MESSAGE: Attached is a Topo layout of Route 60 North
Law Mountain Road ROW Centerline that was reviewed
by Hopi Tribal Archaeologist. Recommendation for us to reroute
to further 130' feet west. Asking for your assistance making
Center line adjustment so we can carry on with proper clearances.

To: Herbert Begay
From: David Thompson
Date: 09-08-03
Subject: Low Mountain 60 North Arc Sites

ROUTE 60 N
 Low Mountain Road
 ARCHAEOLOGICAL SITE

CURVE No. 04

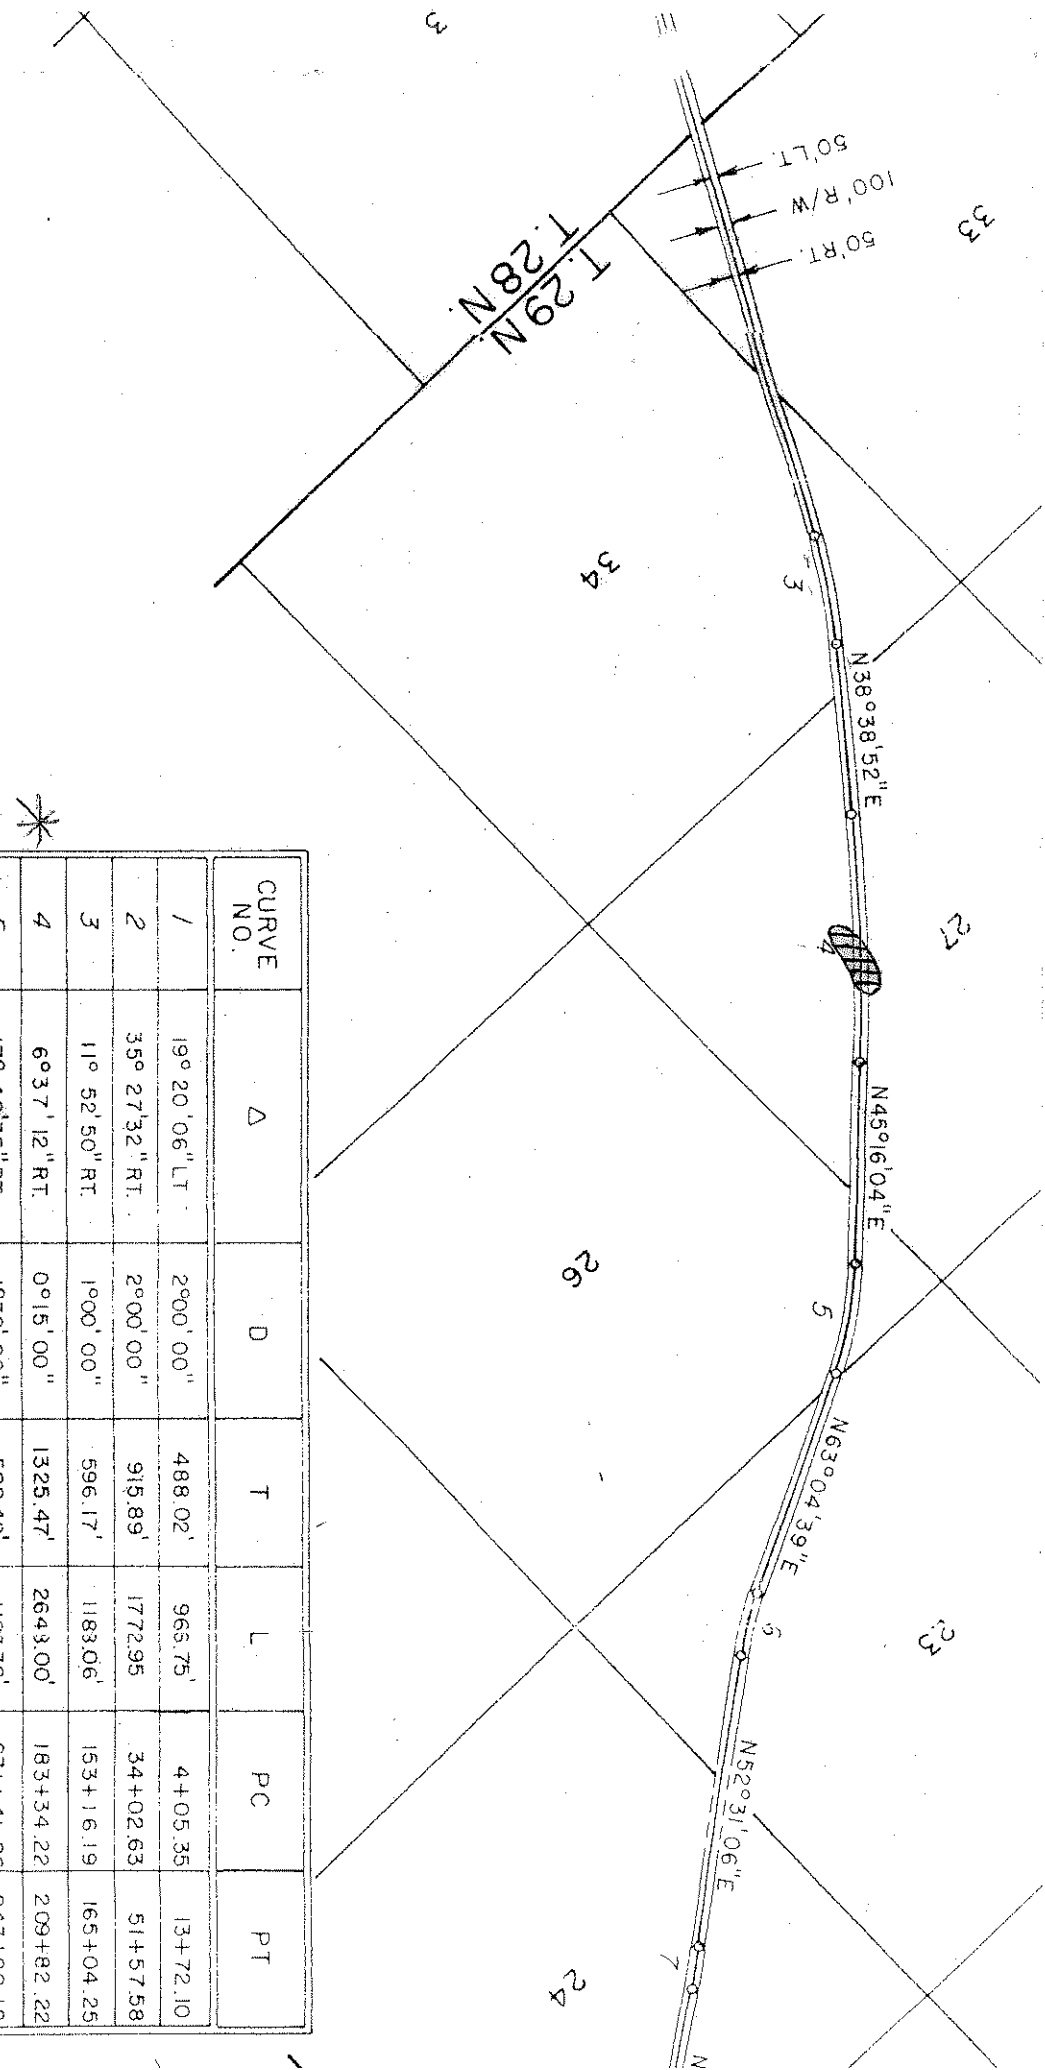
Archaeological

Site. Site increases to the East.

Recommendation from the Haa Tribal CPD Archaeologist to reroute center line 130 feet to the west. CL of ROW alignment located at the East shoulder of existing Route 60 North Dirt Road.

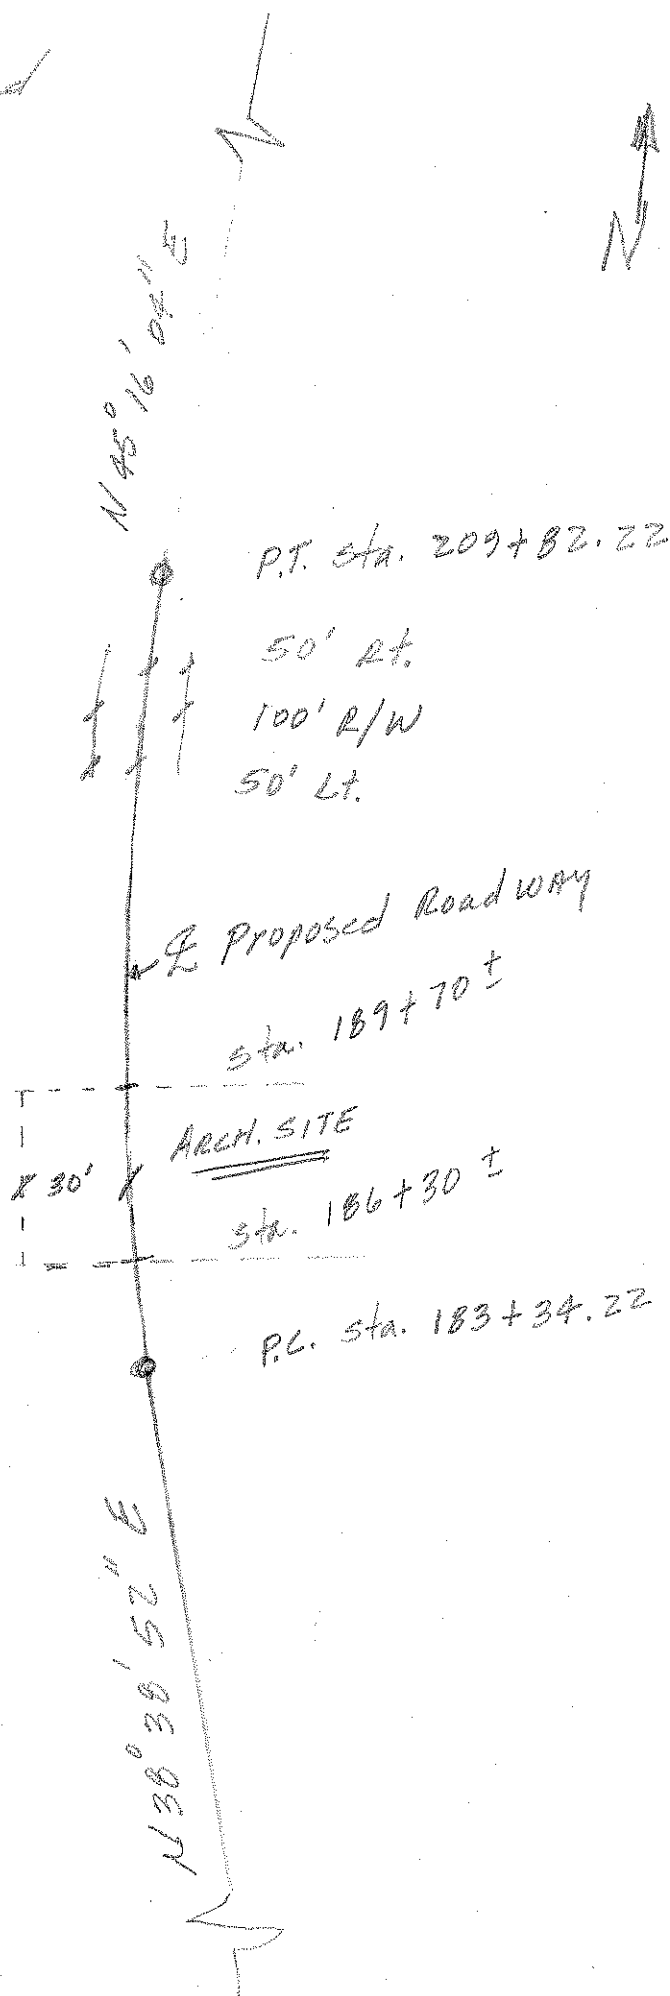
1. The New proposal alignment at the beginning of state highway 264 to the first P.I. point has ruins at the site.(She recommends moving the B.O.P. toward east about 150.00 feet.)
2. Between station 186+30 to 189+70 has plenty of evidences showing a site. She suggests to Move the alignment southwest about 100.00 feet estimates. (Alignment change)
3. A proposal borrow pit six at station 572+00 has been reject due to some finding at the area.
4. A proposal borrow pit seven at station 647+00 has a site on the Northeast corner of the pit, the pit needs to be moved 50.00 feet southwest direction.
5. Lanelle said she will have all her paper work in sometime in the 3rd week of September 2003,on the low mountain arc informing and findings
